RE: RESPONSE TO FURTHER INFORMATION REQUEST IN RELATION TO PROPOSED DEVELOPMENT ON A SITE OF C. 1.4 HA, LOCATED AT TOYOTA LIFFEY VALLEY, LIFFEY VALLEY MOTOR MALL, DUBLIN 22, TO PROVIDE FOR THE EXTENSION TO THE EXISTING MOTOR SALES OUTLET.

SDCC REG. REF. SD21A/0184

Figure 2.2: Extract from NODE Architecture's Dwg. No. FI_1-03

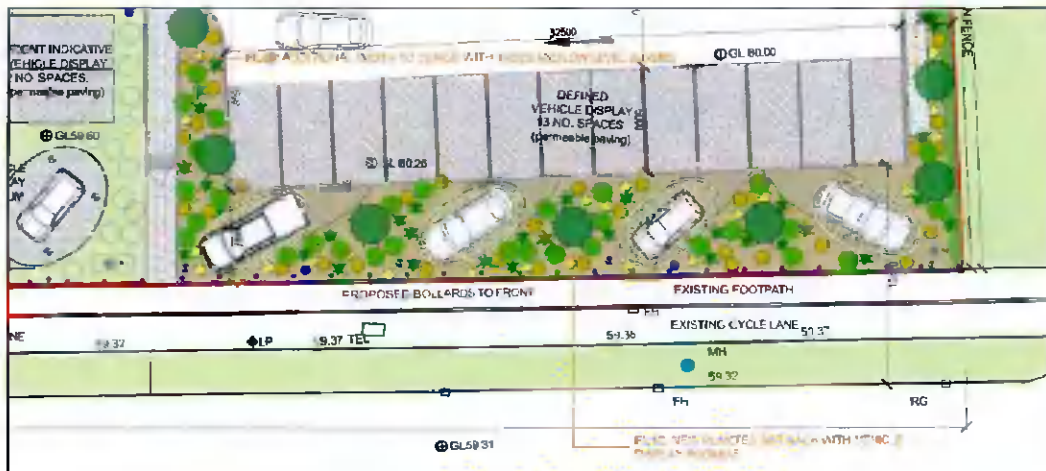
(ii) The Planning Authority considers that the proposed extension to the existing operations, in close proximity to an existing hotel and the Liffey Valley Shopping Centre would not positively enhance the area, which is zoned for Major Retail Centre. With specific regard to the extension of the car parking area and the road/street frontage, the applicant is requested to submit revised proposals to retain the existing roadside berm (at the extension end of the site) and submit proposals to augment same with significant planting proposals, that will enhance the visual amenity of the area. Car parking should be located away from the roadside edge by at least 10m (including footpath and grass verge).

As part of this, SDCC have requested the retention of the existing roadside berm at the extension end of the site. In this regard, we refer to the retail nature of the proposed development and draw attention to the importance of the forecourt from a sales perspective. For a motor sales outlet, the forecourt is an extension of the shop window and is central to the vitality and viability of the outlet. The retention of the berm would provide a visual barrier between the passers-by and the product (the display vehicles).

Nevertheless, in order to respond to Issue No.1(ii), the proposal has been amended and the defined vehicle display bays are now set back from the roadside by over 10 metres. The proposed additional tree and shrub planting is considered to diffuse any potential visual impact associated with vehicle display bays in close proximity to the public realm. In the area between the display bays and the footpath, a number of vehicle podiums have been introduced on the basis that clear visibility of the product from the surrounding area is integral to the viability of the sales outlet. Whilst these cars will sit in closer proximity to the roadside, this part of the site has been augmented with significant planting proposals to strike an effective balance between displaying the product and enabling the outlet to function as intended and the creation of an attractive space which maintains a positive relationship with the surrounding public realm.
